MECKLENBURG COUNTY
HEALTH DEPARTMENT

APPLICATION FOR A RESIDENTIAL SITE IMPROVEMENT PERMIT/ CONSTRUCTION AUTHORIZATION FOR AN ON-SITE WASTEWATER SYSTEM, NEW WELL INSTALLATION, OR REPAIR OF EXISTING WELL

Re: Application for improvement permit for: 3 Bedroom House
Property Location: Sam Wilson Rd Lot 3, Charlotte, NC 28214 (Potion of PID 053-222-03)
Health Department File Number: **10970B (App ID 12114)**

SOIL/SITE EVALUATION for ON-SITE WASTEWATER SYSTEM

PROPOSED PLOT PLAN

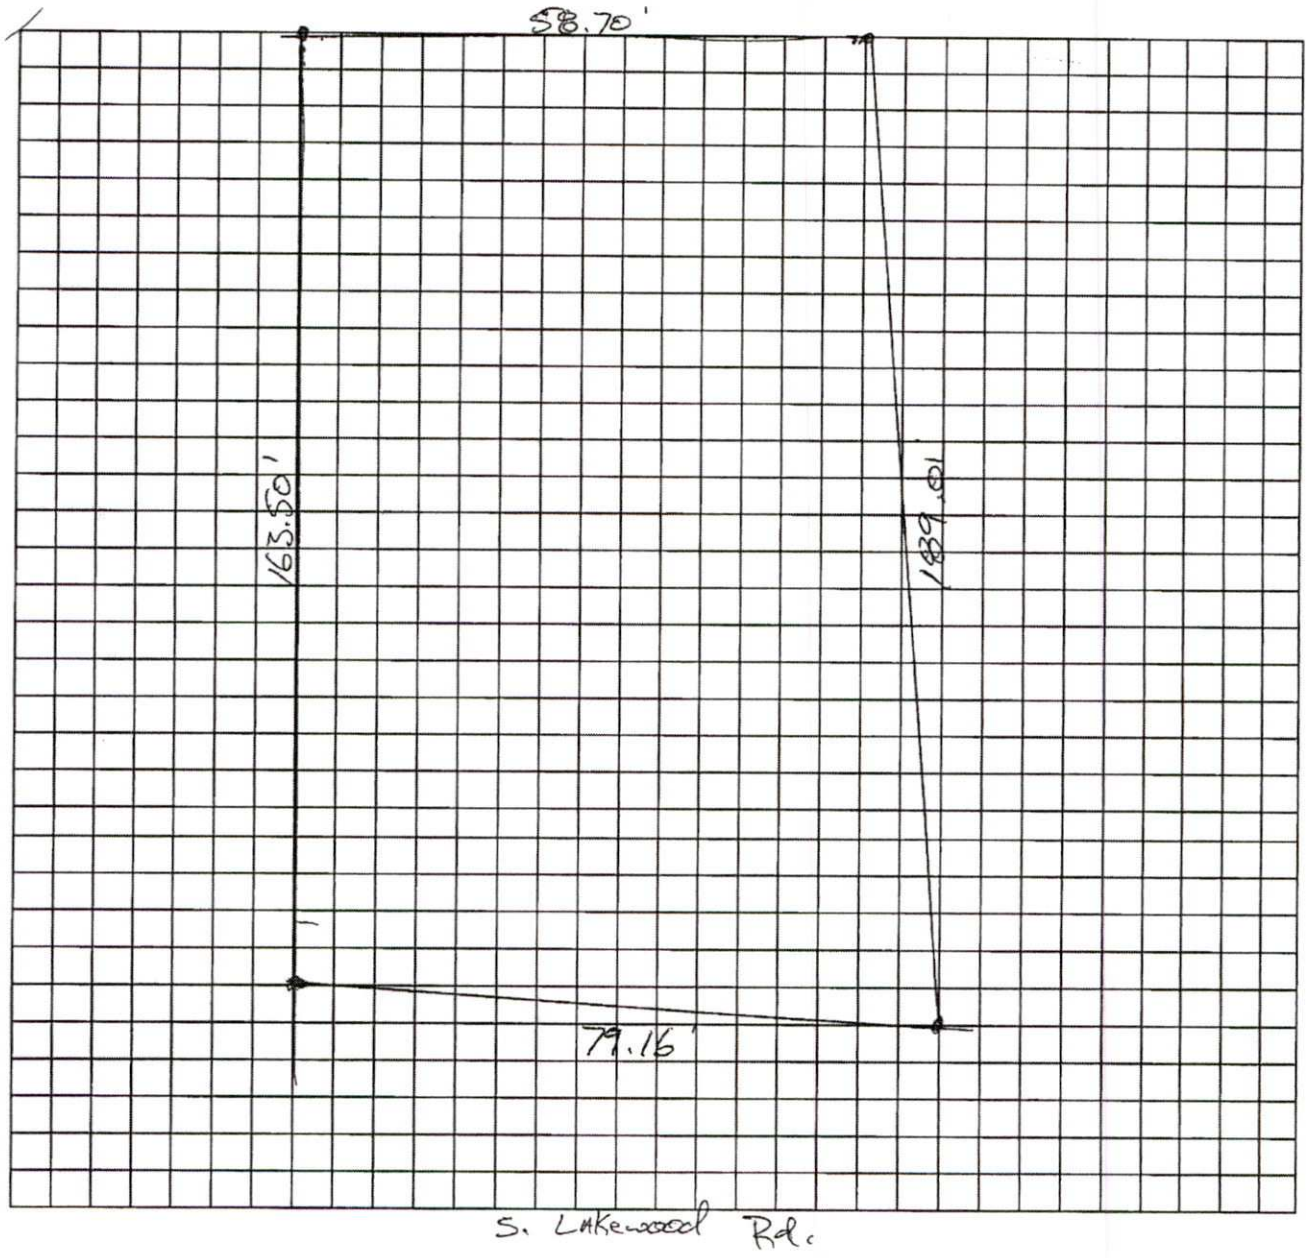
Based on the criteria set out in Title 15A, Subchapter 18A, of the North Carolina Administrative Code, Rules .1940 through .1948, the evaluation indicated that the site is **UNSUITABLE** for a ground absorption sewage system. Therefore, your request for an improvement permit is **DENIED.** A copy of the site evaluation is enclosed. The site is unsuitable based on the following:

- ☐ Unsuitable soil topography and/or landscape position (Rule .1940)
- ☐ Unsuitable soil characteristics (structure or clay mineralogy) (Rule .1941)
- ☐ Unsuitable soil wetness condition (Rule .1942)
- ☐ Unsuitable soil depth (Rule .1943)
- ☐ Presence of restrictive horizon (Rule .1944)
- ☒ Insufficient space for septic system and repair area (Rule .1945)
- ☒ Unsuitable for meeting required setbacks (Rule .1950)
- ☐ Other (Rule .1946)

The site evaluation included consideration of possible site modifications, and modified, innovative or alternative systems. However, the Health Department has determined that none of the above options will overcome the severe conditions on this site. A possible option might be a system designed to dispose of sewage to another area of suitable soil or off-site to additional property.

However, the site classified as **UNSUITABLE** may be classified as **PROVISIONALLY SUITABLE** if written documentation is provided that meets the requirements of Rule .1948(d). A copy of this rule is enclosed. You may hire a consultant to assist you if you wish to try to develop a plan under which your site could be reclassified as **PROVISIONALLY SUITABLE.**
